**ERA Ref.:** EA/00047/20  
**Planning Ref.:** PA/02566/18  
**Proposal Description:** To reactivate permit PA/4036/93 Hardstone Quarry No.7, to extract hardstone mineral up to +200m (AMSL) and restore quarry to its original level matching adjacent field/garigue levels.  
**Location:** Hardstone Quarry No. 7, Gebel Ciantar, Fawwara, Siggiewi, Malta

### **Environmental Impact Assessment Regulations (S.L. 549.46)**

### **Flora, Fauna and Natural Habitats Protection Regulations (S.L. 549.44)**

**Figure 1:** Proposed restoration plan – final phase – after-use – solar farm (Source: Eapps documents PA/02566/18 – 123g).

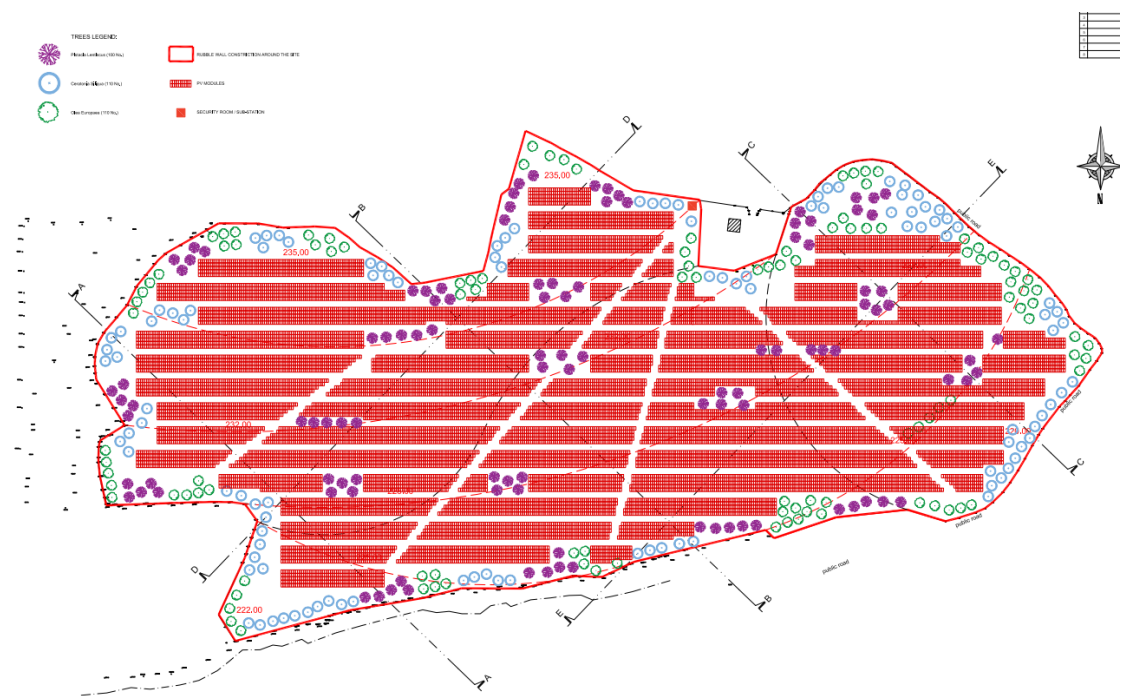
With respect to phase 2, the after-use of the site, ERA has noted the submission of doc PA/02566/18 – 123g, outlining the proposed after-use of the site as a solar farm (also refer to Figure 1). Since ERA’s previous correspondence (docs 103a-b), the Solar Farms Policy has been updated (June 2021) following the conclusion of a Strategic Environmental Assessment (SEA) and a plan-level Appropriate Assessment (AA). In this instance, the proposed after-use can now be assessed further.

- 1.1. The PDS for PA/02566/18 had provided two alternatives, being the restoration back to agricultural land or the use as a solar farm. Though restoration of the quarry void through infilling with inert material is still proposed, the proposed after-use as a solar farm will prevent the reinstatement of the site to agricultural land or back to its pre-existing land cover. On noting the location of the said quarry within a sensitive coastal location predominantly characterised by garrigue and agricultural land, the proposed solar farm is not a preferred use from an environmental point of view.

- 2.1. The proposed solar farm is likely to conflict with the surrounding natural landscape, designated for its high landscape value ('Diversi Rdumijiet' Area of High Landscape Value (AHLV), designated as per Govt. Notice 400 of 1996). In this regard, the solar farm would require adequate screening through the inclusion of a landscaped buffer surrounding the entire solar farm. The landscaped buffer shall be 5m wide at the southern and western boundary of the site, in view of its exposure to the predominant winds (to ensure adequate space for the survival of the planted species). In the other areas, the buffer shall be at least 3m wide. Planting should consist in species typical of the surrounding environment and include low rubble walls to adequately shelter planted species and provide a smoother visual transition into the landscape. Planting along the cliff face should be low-lying, to avoid unintended visual intrusiveness. To visualise such site treatment, photomontages are to be submitted, illustrating the proposed solar farm from various viewpoints around the site.

adverse effects on the ecological features in the area. In this regard, the ground surface should be kept porous, and the use of herbicides avoided, to allow the growth of wild vegetation, which in turn would allow various species of wildlife to return back to the area. ERA notes and commends that clusters of landscaping have already been included within the plan of the proposed solar farm, to provide ecological steppingstones. Such clusters should consist of species typical of the surrounding ecology and landscape, similar to the landscaped buffer surrounding the site.

- 2.5. With respect to run-off management, any water run-off generated on site should be adequately captured in soak-away reservoirs for the gradual infiltration of surface runoff into the ground (to recharge the perched aquifer), and reuse on site (e.g. for irrigation or cleaning of PV panels). Stringent attention should be made to the cleanliness of the inert infill material to avoid dispersion of contaminants into the ground and the perched aquifer. Geotechnical advice would be required for the inclusion and location of such reservoirs in the plans, to ensure that impacts on the cliff face stability are avoided.

- A landscaping plan, showing the required green buffer, clusters of landscaping within the solar farm and porous ground cover to allow growth of wild vegetation, in line with the requirements specified in paragraphs 2.1 and 2.2;

- Photomontages, illustrating the proposed solar farm with the afore mentioned required landscaping, from various viewpoints around the site;
- Updated plans, including the required soak-away reservoirs; and
- Confirmation that on-site lighting during operations of the solar farm will be limited to an intruder-triggered safety and security system (to avoid continuous nocturnal lighting), and all noise generating equipment will be duly muffled to avoid chronic operational noise.
